# TECHNICAL REVIEW OF PROJECT-SPECIFIC DRILL CUTTING DISPERSION MODELLING FOR TILT COVE EXPLORATION DRILLING PROJECT ENVIRONMENTAL IMPACT STATEMENT

The submission consists of the following document: Appendix C – Suncor Energy Offshore Exploration Partnership Tilt Cove Exploration Drilling Project (2019–2028) Drill Release Risk Assessment.

This Science Response Report results from the Regional Peer Review: Technical Review of Project-Specific Drill Cutting Dispersion Modelling for Tilt Cove Exploration Drilling Project Environmental Impact Statement, which was held on March 30, 2023.

Figure 1. Scenario 1: Predicted thickness of seabed deposition of discharged mud and cuttings resulting from all drilling sections (top) and from only the riserless drilling sections (bottom) during the summer at EL 1161 (Suncor Energy 2019).

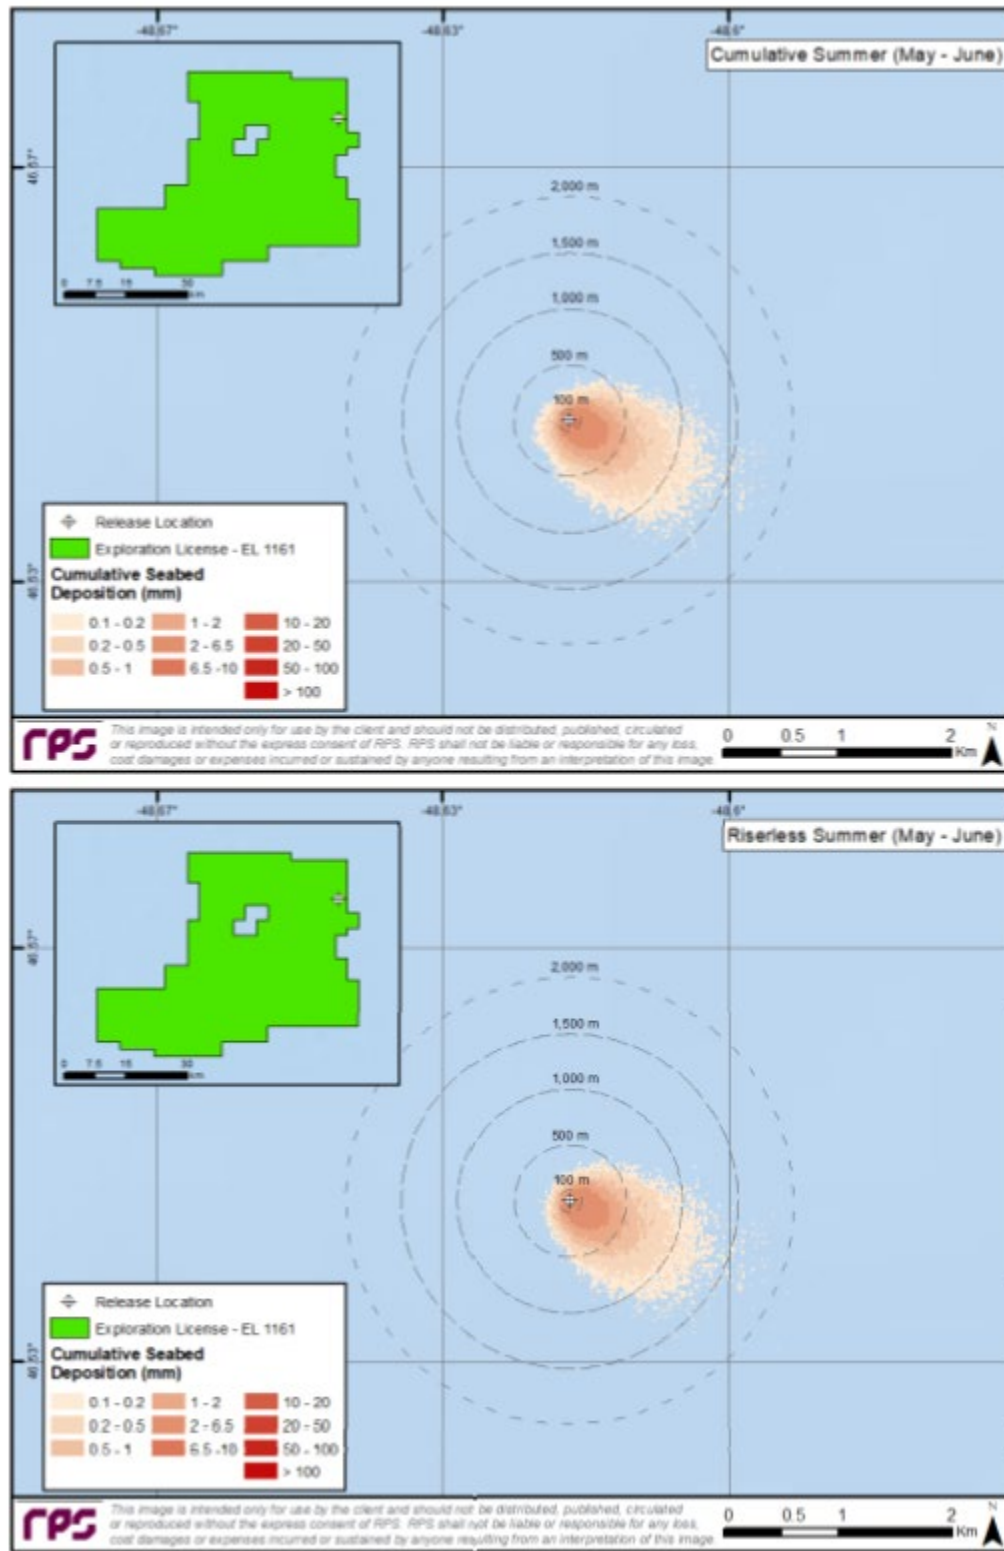
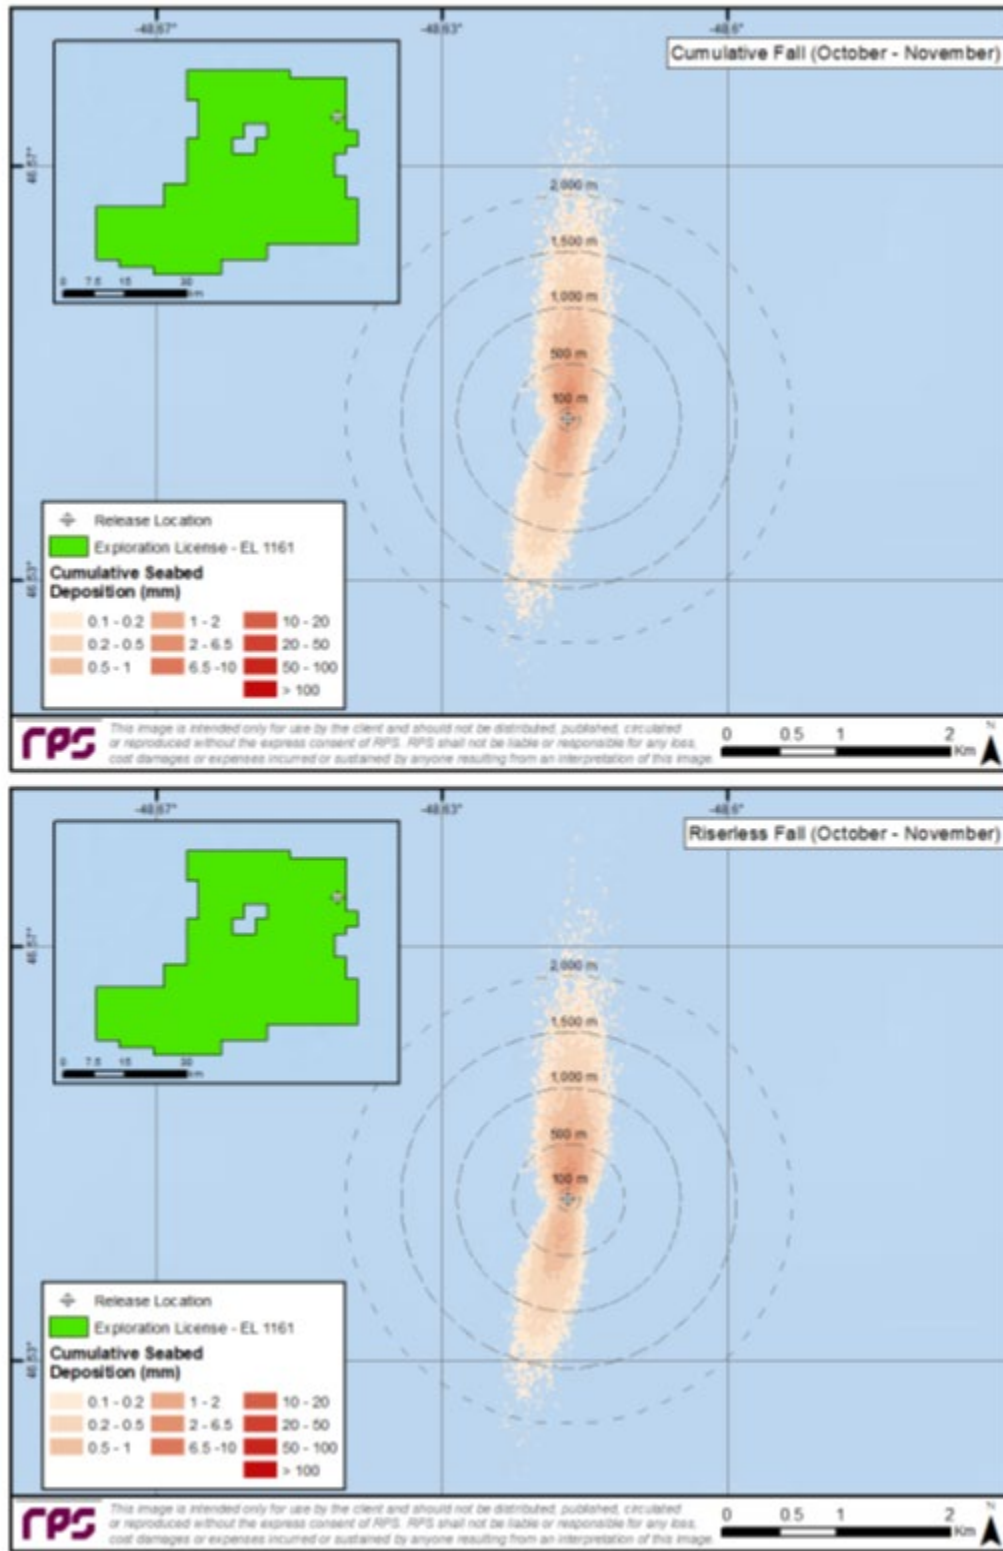
There are issues with the model results. The total deposition during the riserless stages (stage 1 and 2) is more or less identical to the deposition over the 5 stages together (Figures 1 and 2 [Figures 3-1 and 3-2 in Suncor Energy 2019]). This suggests that the sediments from stages 3 to 5 do not deposit at all and that the model loses track of them. This is more or less confirmed on page 16 of Suncor Energy (2019), “*approximately 78% of the total mass of all sections combined are predicted to be discharged near the seabed, where they settle rapidly. During the remaining sections of drilling, where the remaining roughly 22% of mass is discharged near the sea surface, smaller particle size fractions with low settling velocities were transported greater distances as they settled through approximately 100 m of the water column*”. In Table 1 (Table 2-1 in Suncor Energy 2019), the total volume discharges is approximately 10,000 m<sup>3</sup> (480 m<sup>3</sup> cuttings + 9,831 m<sup>3</sup> mud). A simple calculation based on Table 2 ([Table 3-1 in Suncor Energy 2019] deposition thickness x surface area) suggests that the total volume of material deposited in the model varies between 1,350 m<sup>3</sup> (minimum approximation) and 2,800 m<sup>3</sup> (maximum approximation). This appears to imply that only 13.5–28% of the particle volume actually deposits according to the model. The consequences of the model not accounting for this fraction of sediment should be addressed.

Figure 3. Average surface current speed (cm/s) in color, and speed and direction presented by red vectors offshore Newfoundland from HYCOM (2006–12). The black X represents the EL 1161 drilling site (Suncor Energy 2019).

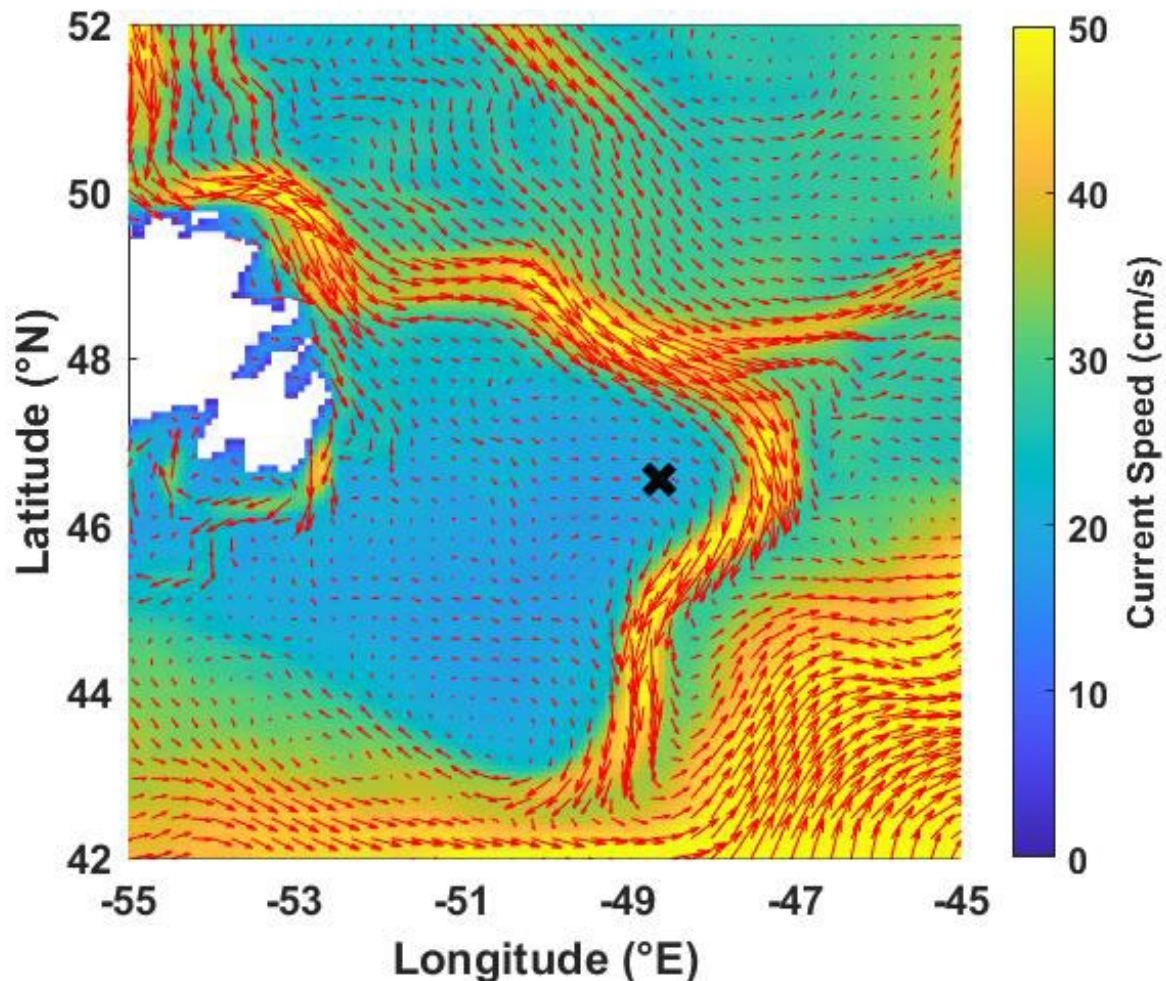
**Section 1.2, paragraph 3:** Figure 3 (Figure 1-3 in Suncor Energy 2019) “...illustrates that the site is close to the inshore branch of the Labrador Current near the Flemish Cap”. This is not the definition of the inshore branch, which is usually defined as the current flowing along the NL coast (in contrast with the main branch of the Labrador current that flows on the continental shelf break). The inshore branch further splits north of the Avalon Peninsula with part of the flow merging offshore with the main branch of the Labrador current and the remaining flowing through the Avalon channel near St. John’s.

Figure 4. Monthly average (grey solid) and 95<sup>th</sup> percentile (orange dashed) HYCOM surface current speed (cm/s) statistics at EL 1161 (Suncor Energy 2019).

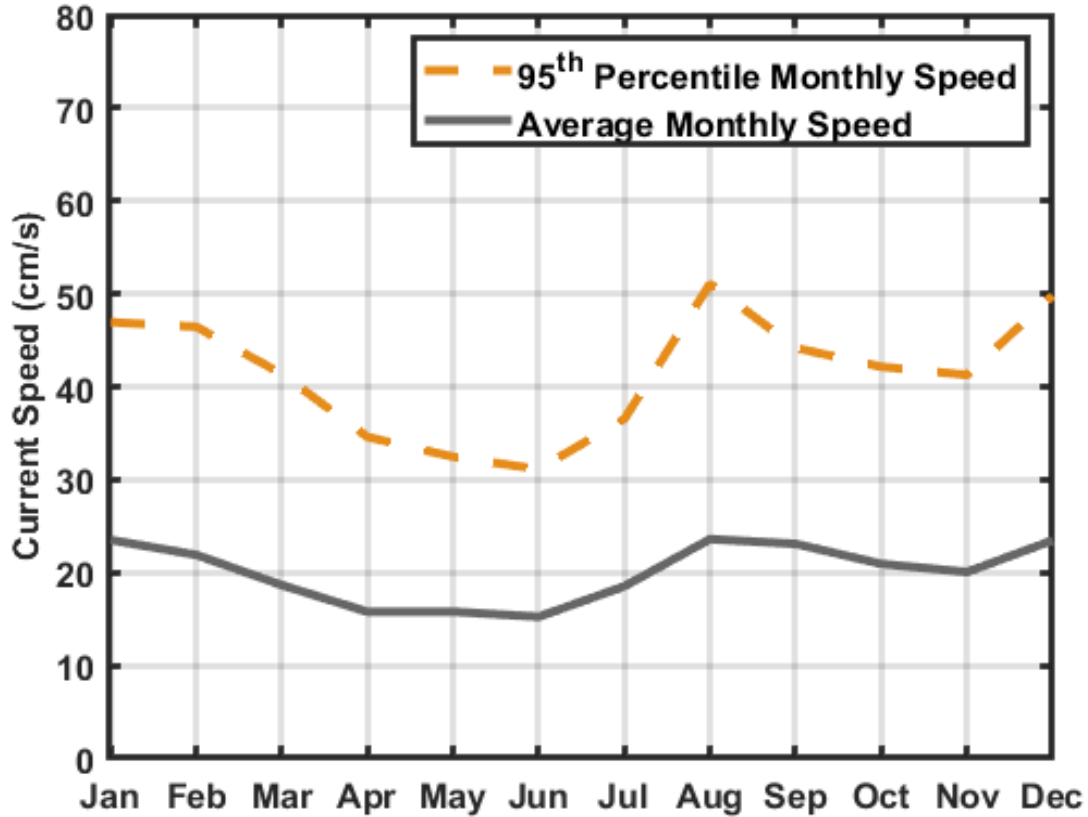
**Figure 4 (Figure 1-5 in Suncor Energy 2019):** The authors describe the surface currents in the model, however, the bottom currents and subsurface currents are much more relevant in this study (see page 21, paragraph 2 of Suncor Energy [2019], “Summer simulations for the EL 1161 site were predicted to have weaker subsurface current regimes with moderate directional

variability, when compared to the fall simulations”). As such, using the surface currents to analyze the variability in the environment is not applicable for this study.

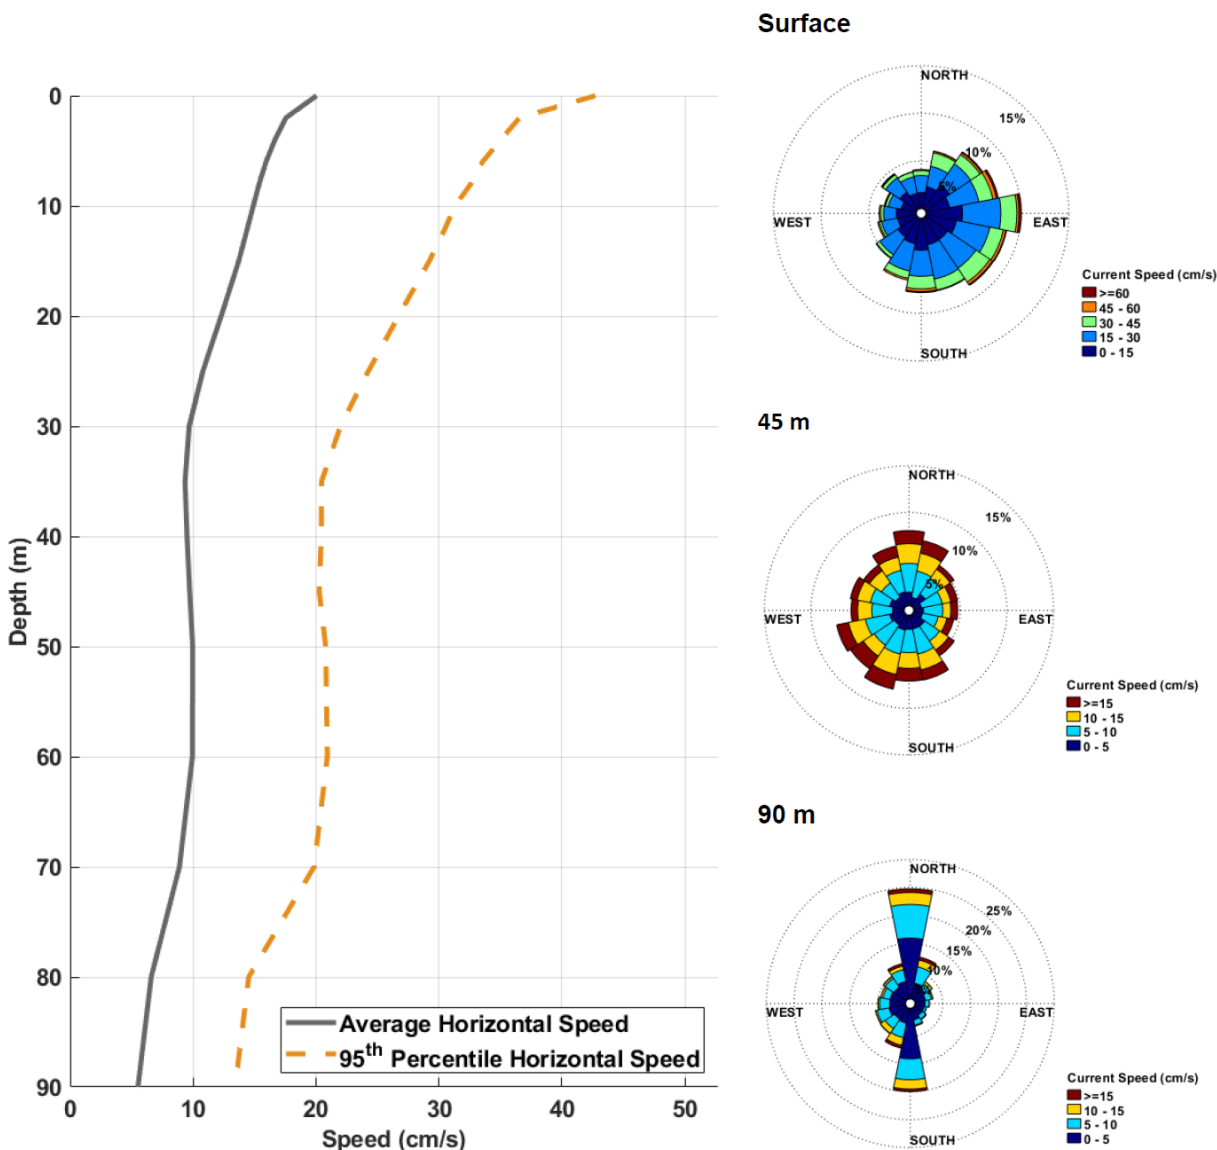
**Figure 5 (Figure 1-6 in Suncor Energy 2019):** A subject matter expert commented that the current rose at 90 m is quite different than higher in the water column. This may be important for the simulation. The text says that the proposed drilling site is 100 m deep, however the HYCOM currents displayed in this figure only extend to 90 m. The currents in the bottom 10 m are unknown, however, and important for deposition simulations. This is another situation where it is important to describe the vertical grid spacing so that readers can understand how well the bottom boundary layer is resolved. Also of note, fall data in Figure 2 (Figure 3-2 in Suncor Energy 2019) match with the deep current rose (Figure 5), but summer data in Figure 1 (Figure 3-1 in Suncor 2019) are more similar to the surface rose (Figure 5). Further explanation or investigation for this was not included in the appendix.
